March 2005

TOPIC: SLACK IN ENGINE WIRE HARNESS

AFFECTED: IS1500ZKAV1944

Figure 1. Engine out of chassis

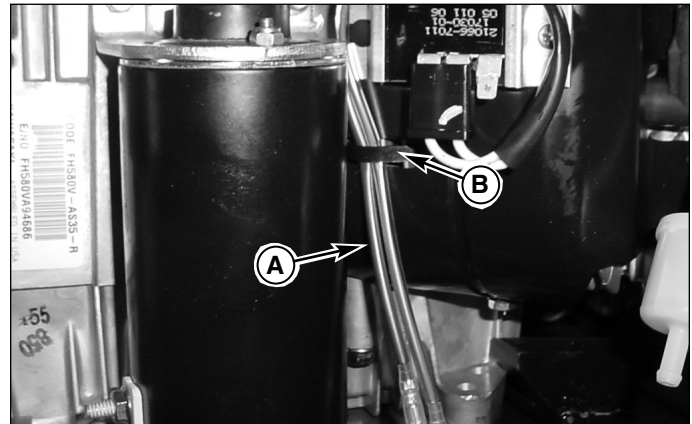
Ferris Industries has determined that the engine wire harness retaining tab, on the left-hand side of the 19HP engine is not retaining the wire harness properly. If not properly retained, the potential exists for the wire harness to contact the ring gear of the engine flywheel, causing an electrical system malfunction.

1. Locate the engine wire harness (A) on the left-hand side of the machine.
2. Pull the green and black wires down to remove all slack.
3. Loosely install a small tie wrap over the green and black wires of the engine harness.
4. Slide the tie wrap up and over the harness retaining tab (B).
5. Tighten the tie wrap and trim excess.
6. Firmly press the harness retaining tab inward to insure that all slack in the harness has been removed.
